Response to Design Guidelines for Pedestrian-Oriented Business Districts

Development Standards List

File: DRV22-00466

CITY OF KIRKLAND URBAN FORESTRY CHECKLIST

Figure 1. Subject area requiring tree protection

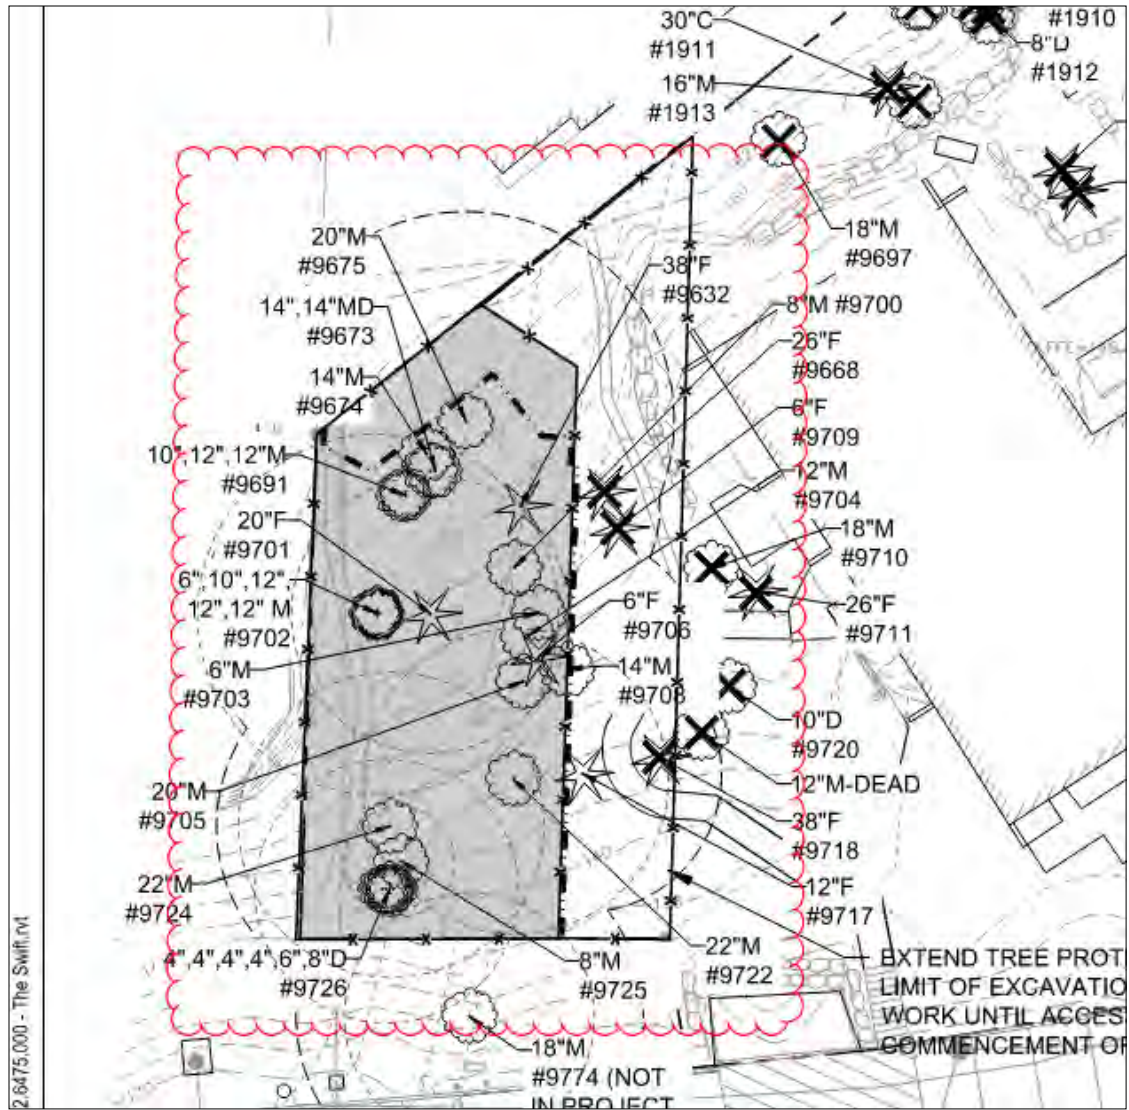
1. Tree Protection Area at the western edge of the site will be impacted by proposed pathway, stairs, and amenities. Tree protection during development shall meet standards of KZC 95.32. Work with project arborist to prepare project-specific specifications for constructing proposed improvements throughout this area. Schedule a site meeting with the City Arborist, Planning Official, and Project Arborist to assess impacts and protection measures. On-site arborist monitoring and non-invasive excavation methods (air) will likely be required throughout the duration of work within this area.

2. Proposed hardscapes/improvements in Tree Protection Area shall be assessed to minimize impacts to trees. This may include:
 - a. Adjusting locations based on field truthing of tree locations and impacts

- b. Utilizing pervious materials and/or options that require less excavation and compaction to install
 - c. Installing root barriers to prevent future root and infrastructure conflicts
